Re: Objection to PLN2020/52

Re: Objection to PLN2020/52

The following document provides strong evidence that the Land Capability Assessment [LCA] within the permit application fails to meet EPA Code of Practice, Best Practice<sup>1</sup> for LCA as well the minimum standards set out in the current Municipal Association of Victoria [MAV] Model LCA 2014<sup>2</sup>. It can be demonstrated that it does however, contain **fabricated and misleading information** in order to prevent the **Land Capability Class Rating** for Land Features and General Site Characteristics from attracting the highest assessed level of constraints for the site **Very Poor (5) Major**.

Fig.5 Air photo **calibrates** (below) of **base map fails to apply layer filters of contour lines, catchment boundaries. The 100cm (sic: metre) line marked on photo (left of Grady Lane label) when measured = 3.8cm** which calibrates an irregular scale of 1:2631.6 rendering the map useless

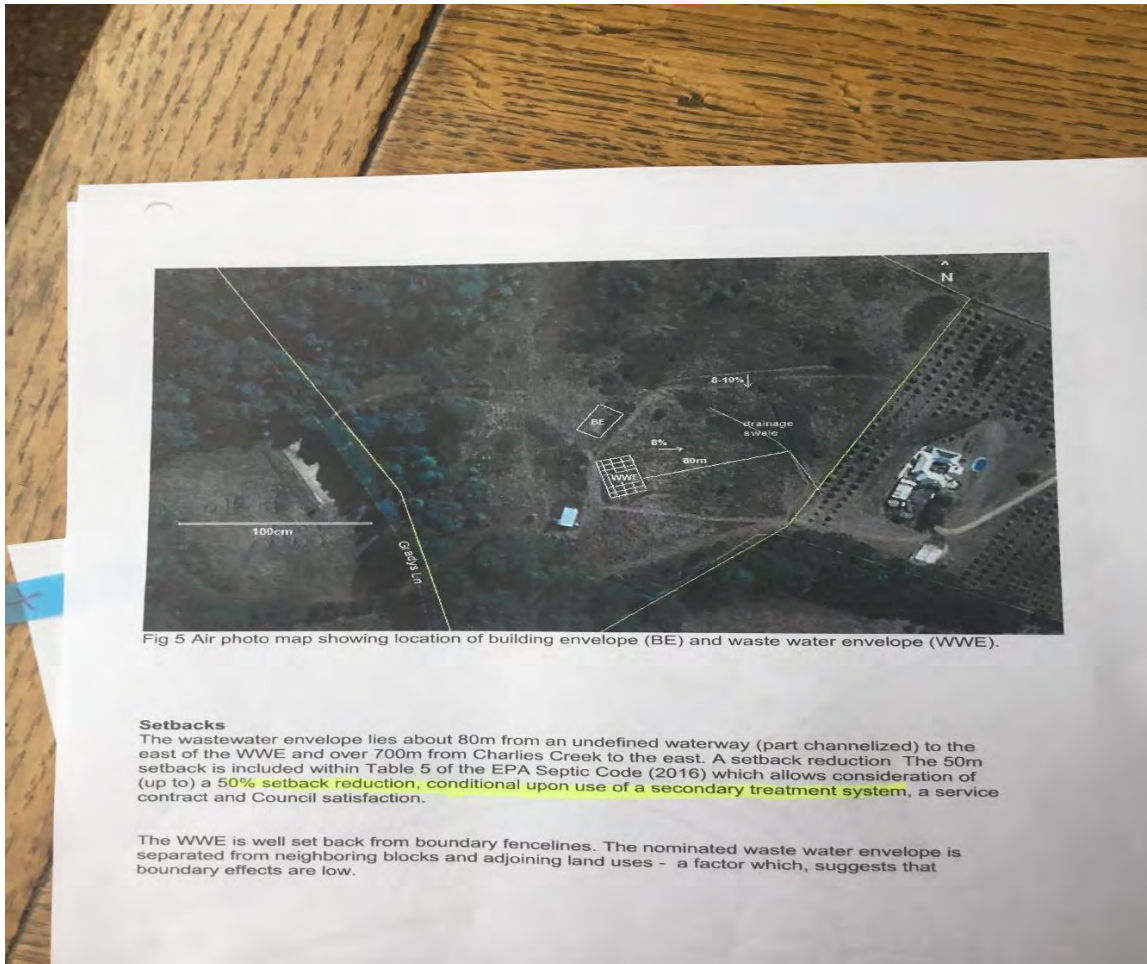
Fig.3 & 4 of the LCA site the location of proposed dwelling between the 620m and 630m contour lines. Both are reproductions of A3 drafting sheets from Appendix 2 and therefore are not to scale.

Plate.1

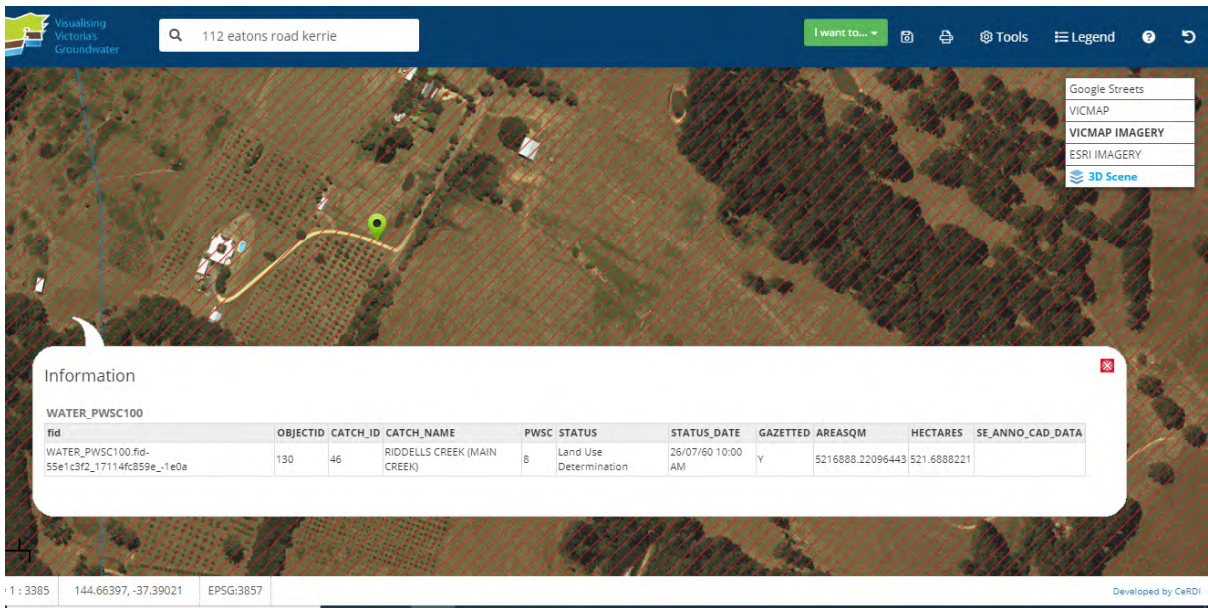
Important to note, all VVG maps submitted in this document are intersected by a [blue line](#) which denotes the open potable supply catchment boundary of **Main Creek (West, in-use)** and Charlies Creek (East, **un-used**) as evidenced below in Plate.1

Plate.2

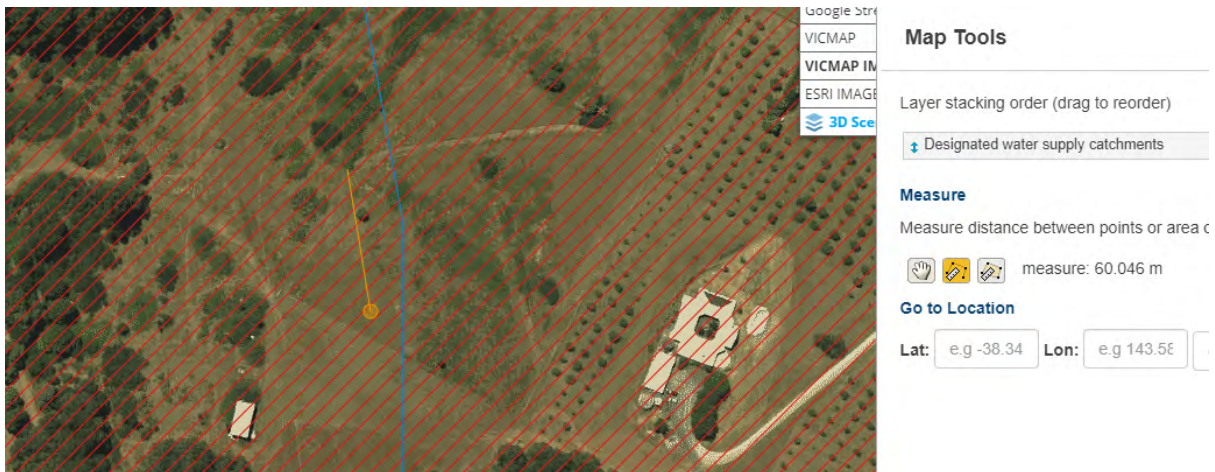
LCA SUMMARY (P.1, Paragraph 3) state:

An area suitable for waste water disposal lies about 60m to the south of the proposed dwelling

The orange line measures 60m from the Building Envelope clearly locating both well to the left of the blue line and therefore well within the Main Creek Catchment boundary

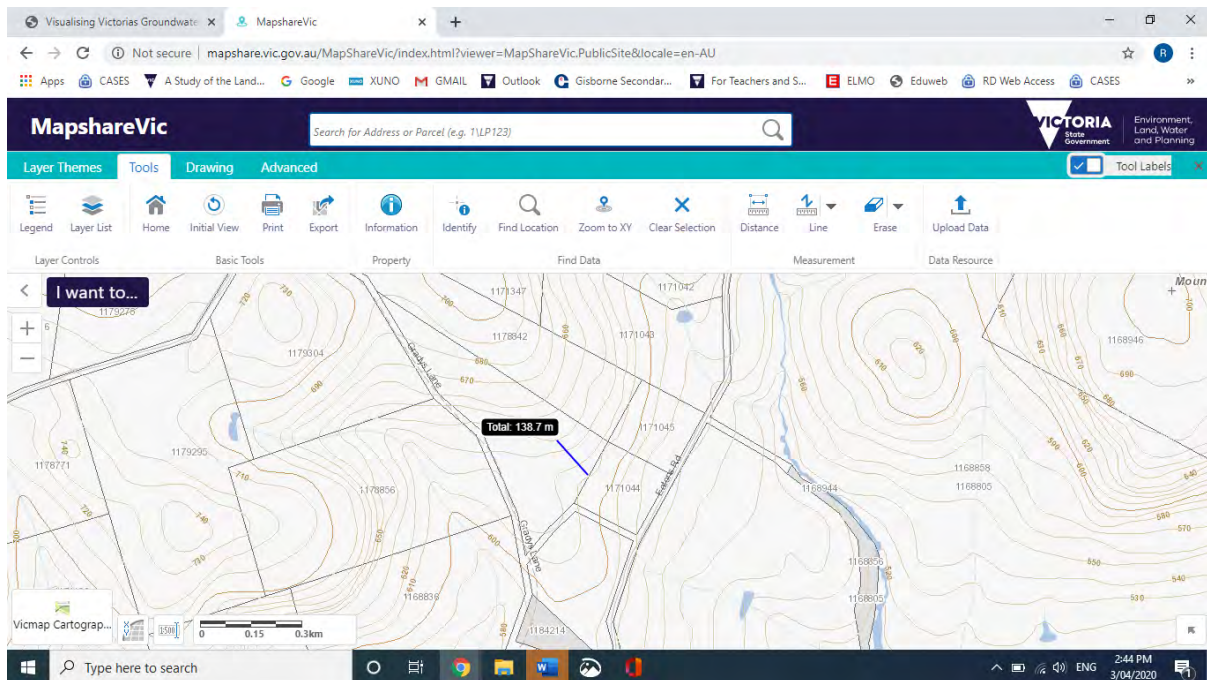
Evidence Slopes on subject land equate to >20% and not 8-12% as LCA claims which equates to **Very Poor (5) MAJOR CONSTRAINT** and not the rating the LCA awards, Fair (3)

**EVIDENCE >20%** Rise 30m/Run 139m x 100 = **22%**

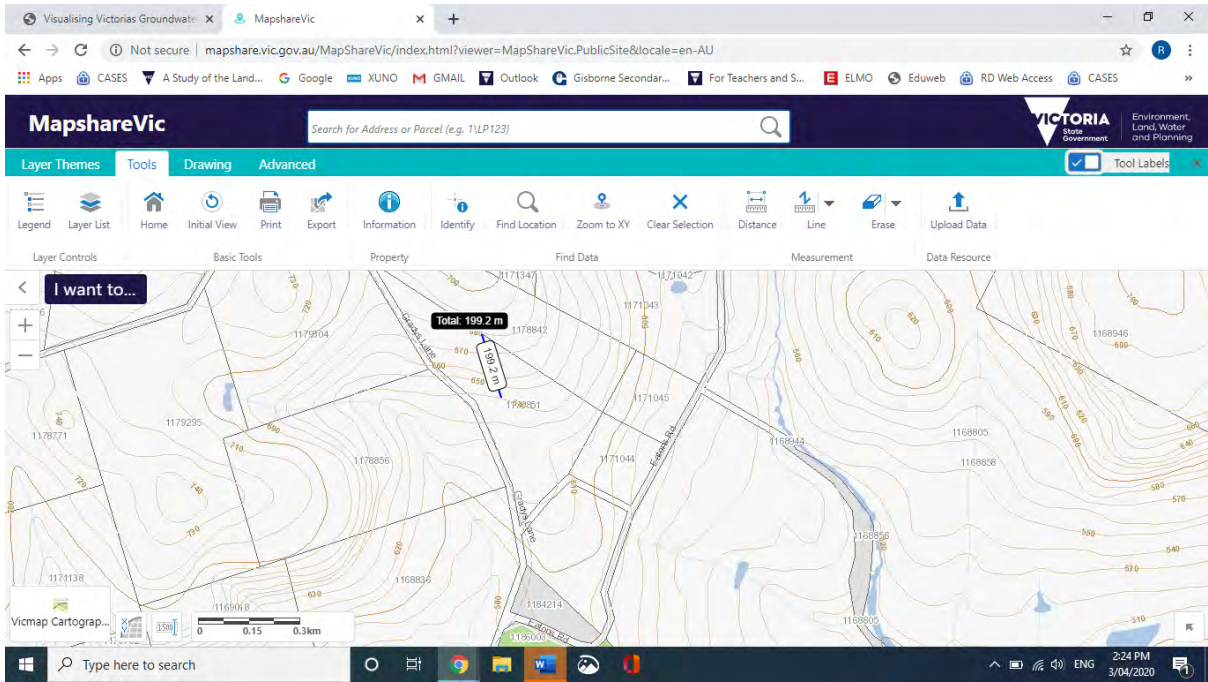
**EVIDENCE >20%** Example of Slope 20% [Rise40m/Run199 x 100]

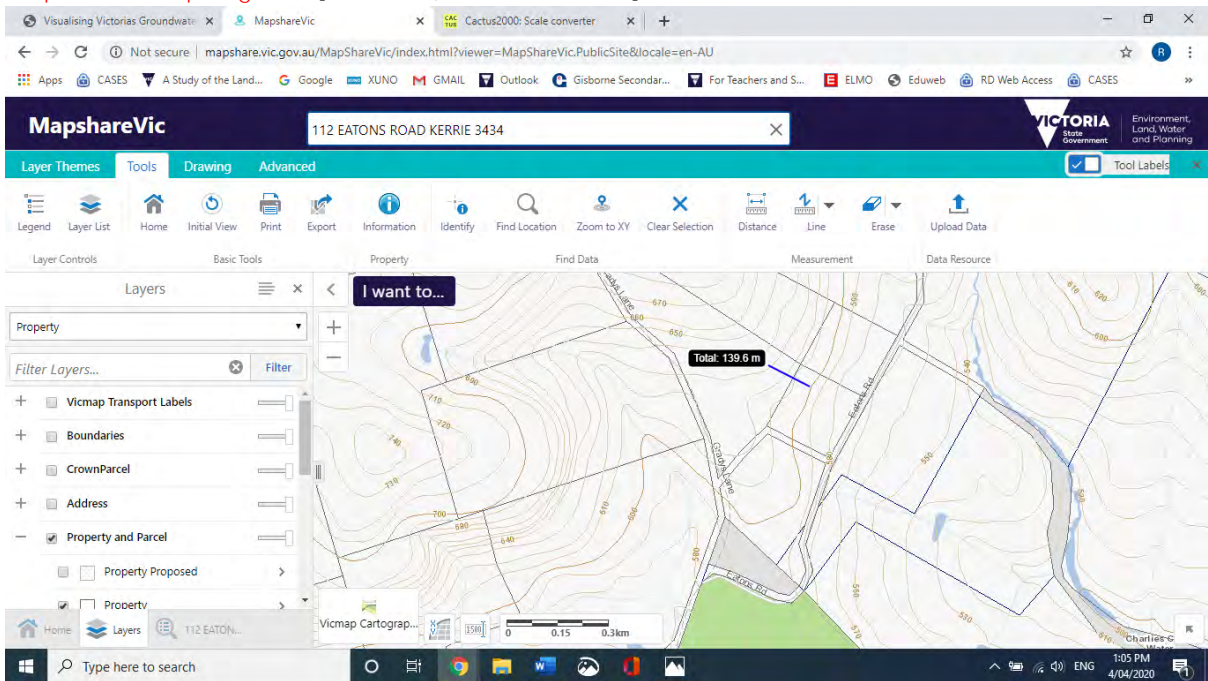
**Slope above Spring 21%** [Rise 30m/Run140m x 100]

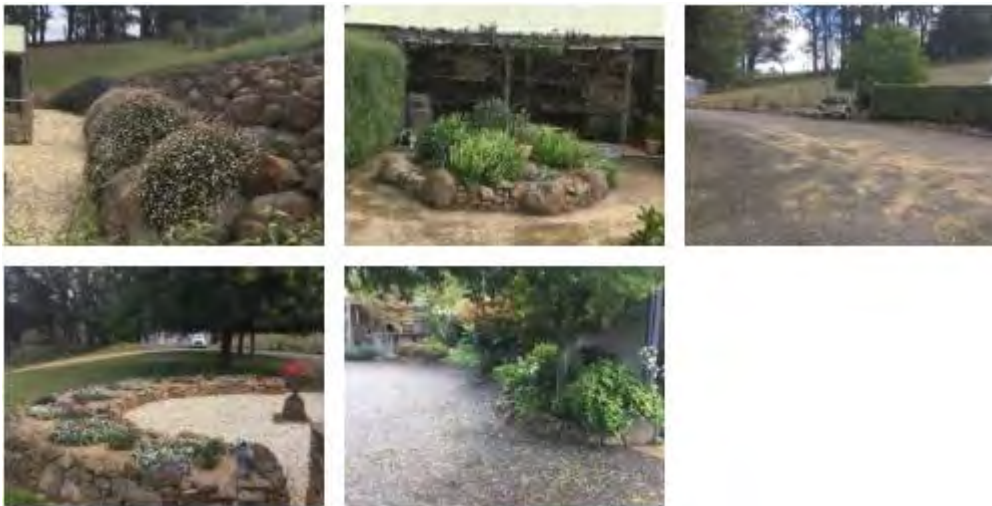
If we refer to Agriculture Victoria, PJ Jeffrey Land System Survey 1981<sup>3</sup> Chapter 4; Soils, Tabular Descriptions p.23, Soil Depth refers to the distance to solid rock or to a cemented layer which severely restricts root penetration and water movement. Chapter 6.18 Mt Charlie Land System state soil depth to be 0.5 to 1m. MAV Model LCA p25 class bedrock <1m as being a **MAJOR CONSTRAINT**

The shallow depth to granodiorite is in further evidence when we have regard to the site-cut on the **adjacent land to the East which turned up 1,000's of granodiorite rocks of varying size which have** been re-used extensively throughout as retaining walls/garden-beds, evidence that allowing the proposed development to proceed would have a much more significant environmental impact and disruption to soil sub-structure than that which was reported and glossed over in the LCA

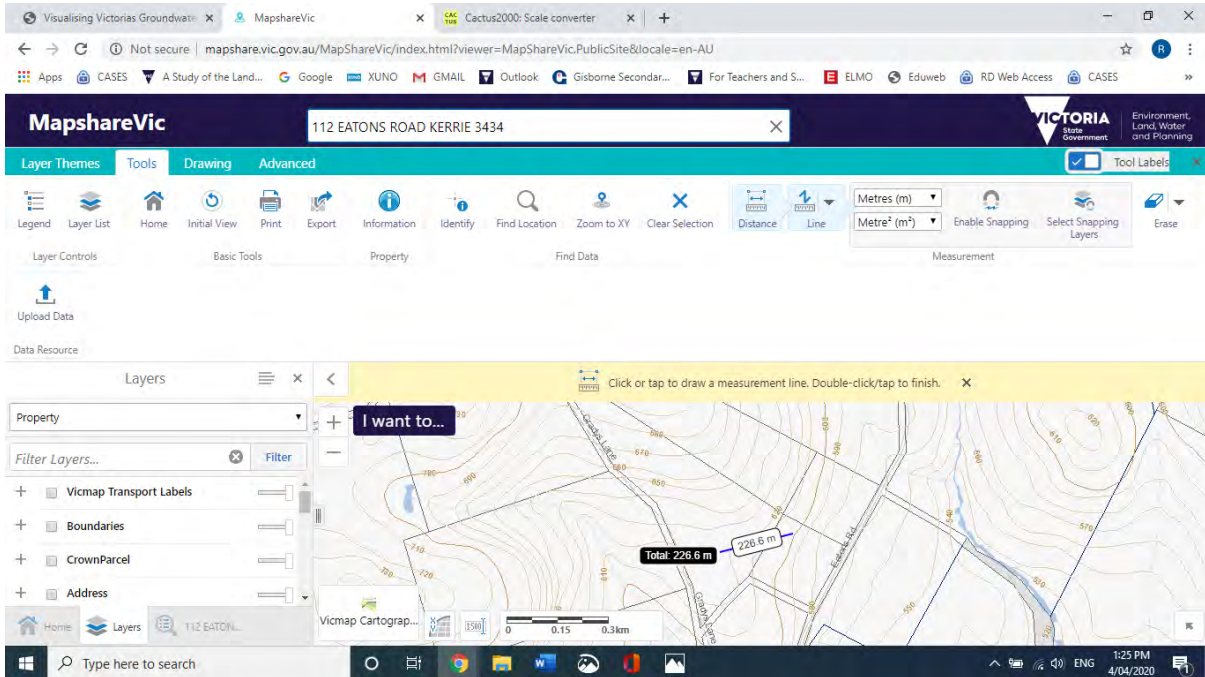
**Compounding this Major Constraint is the severity of the slope as evidenced below:**

**WWE to Adjacent Open Potable Water Slope: 11% [Rise 25m/Run 226 x 100]**

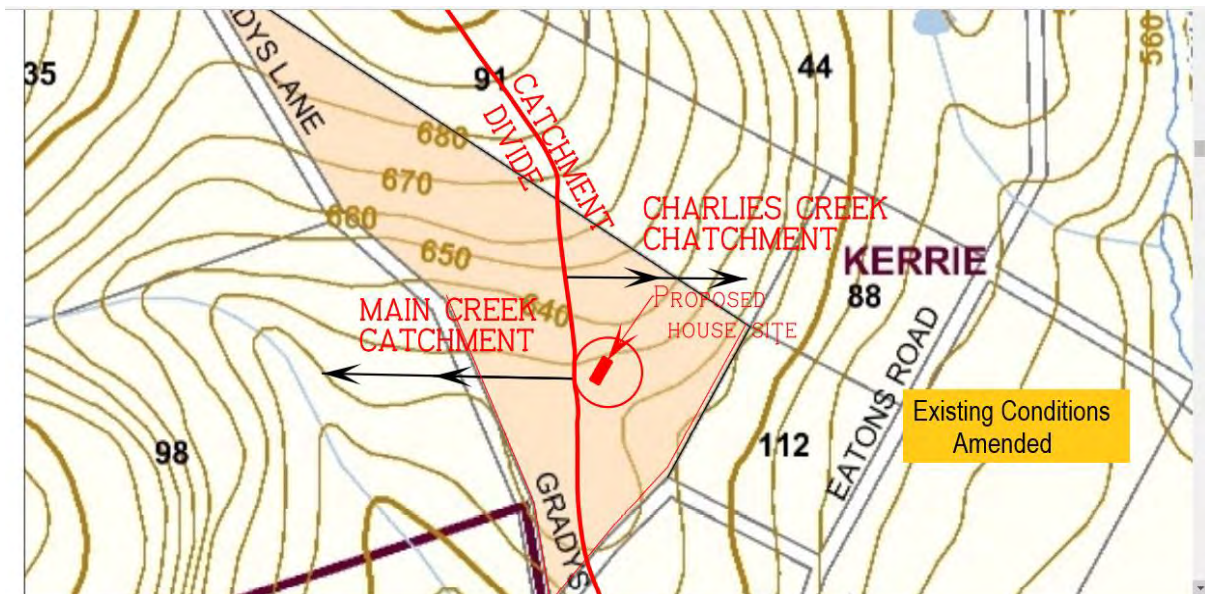
Evidence of false and misleading information - Catchment Boundary Divide (below)

Note: fluidity of the hand drawn red catchment divide in shape and location, not from DELWP

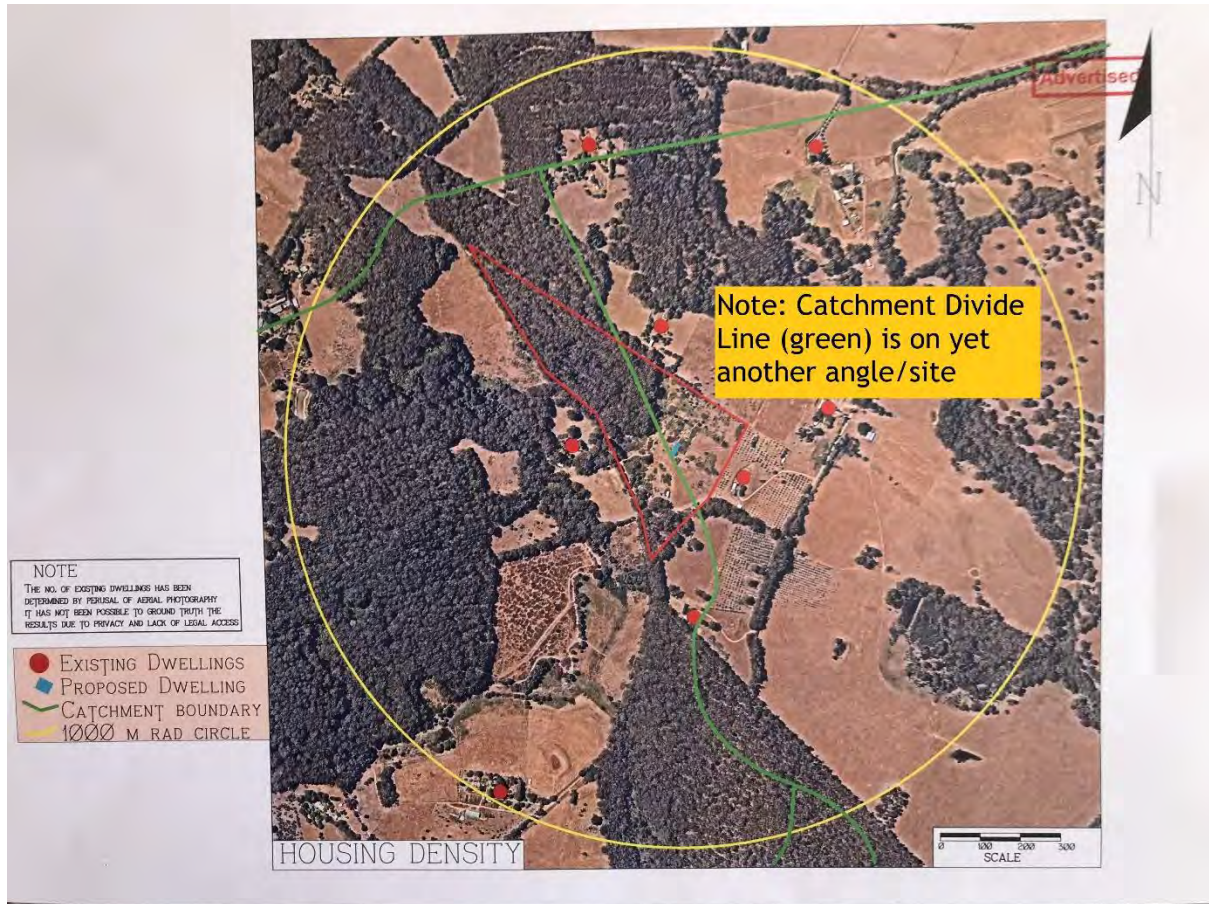
Current DELWP Map taken from spatial mapping tool vvg.org.au (below) show subject parcel and catchment boundary line in blue. Divide shows bulk of the block is within catchment to left, Main Creek, in use for drinking water the remaining small triangular corner of land is situated in Charlies Creek *also* in use for irrigation *both* are Declared Water Supply Catchments, govt gazetted since the 60's.

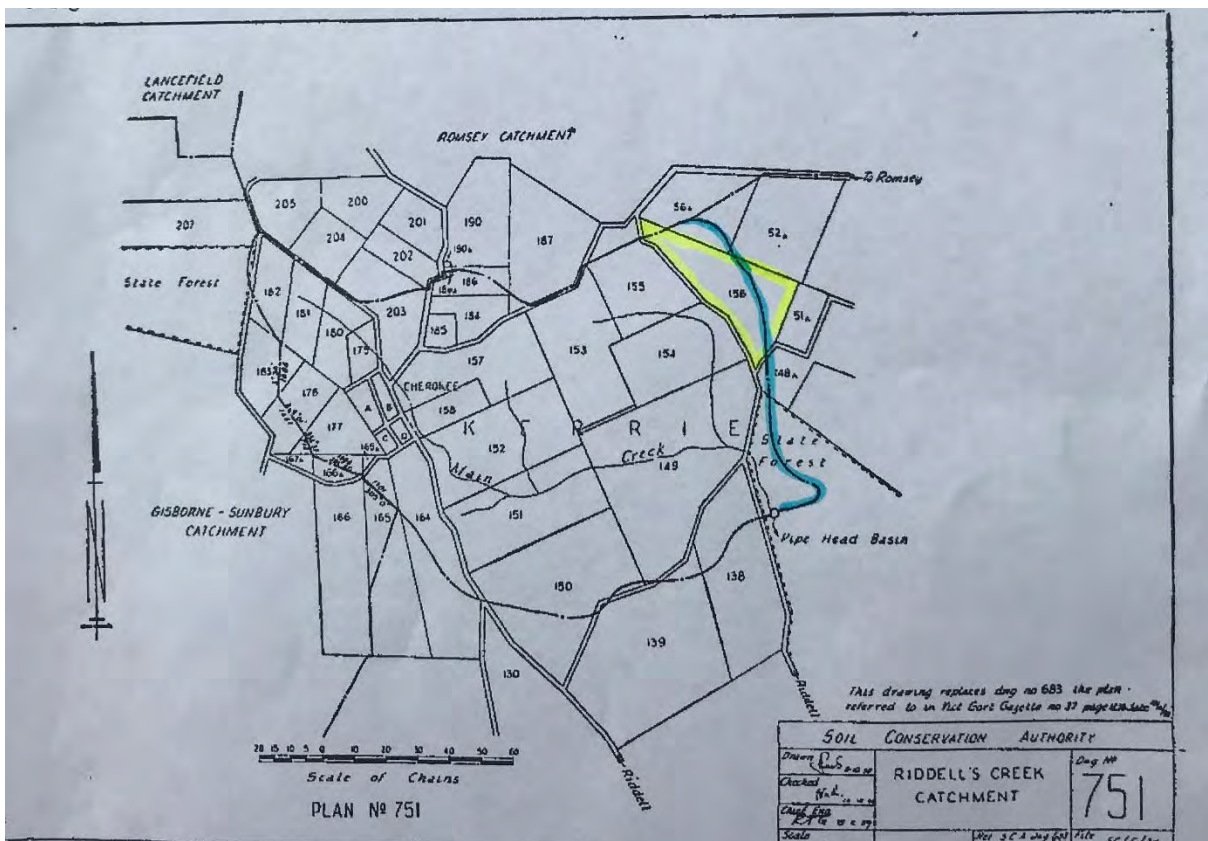
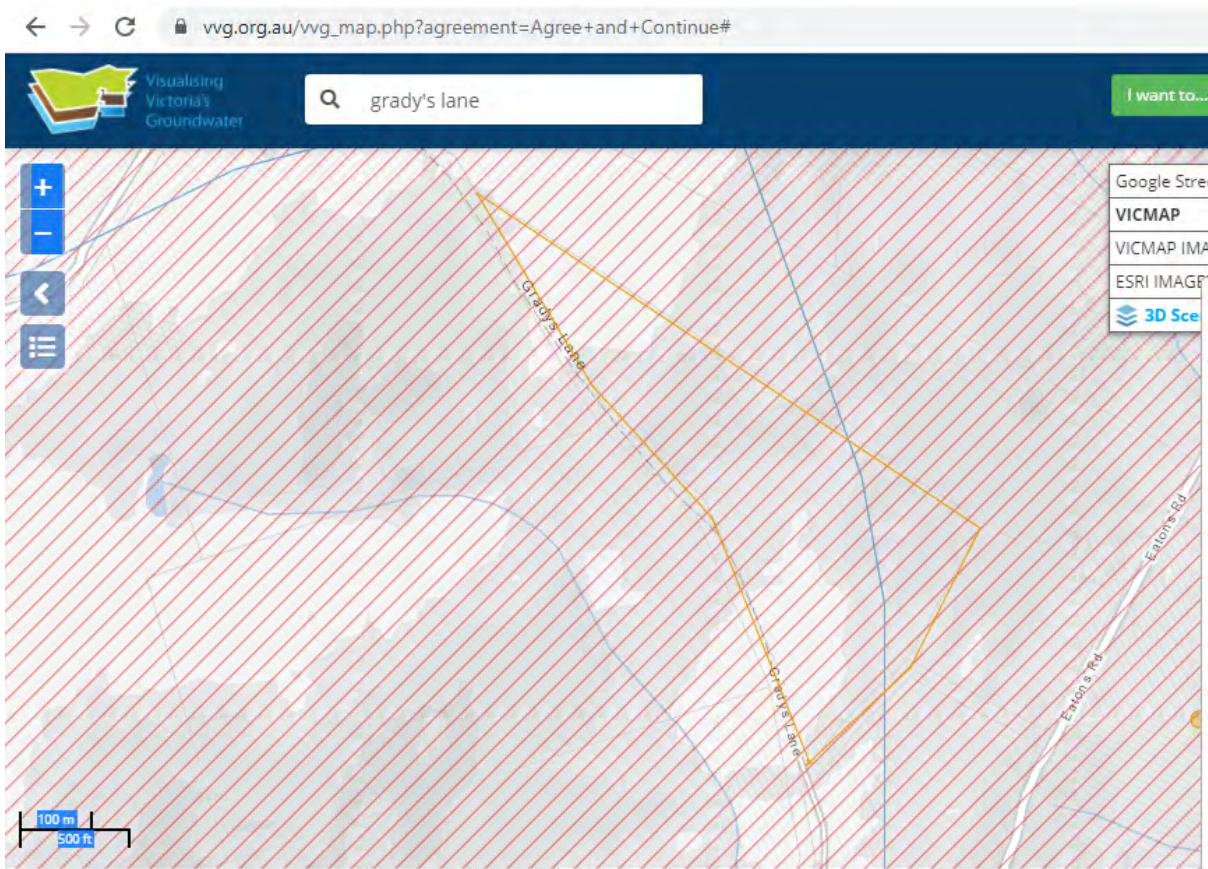
Important to note, no 'source' is ever provided by [REDACTED] but this time (below) the catchment divide is a green line on a much steeper angle than those above

Note: Amended Existing Conditions show dwelling ABOVE mowed track to blackberries
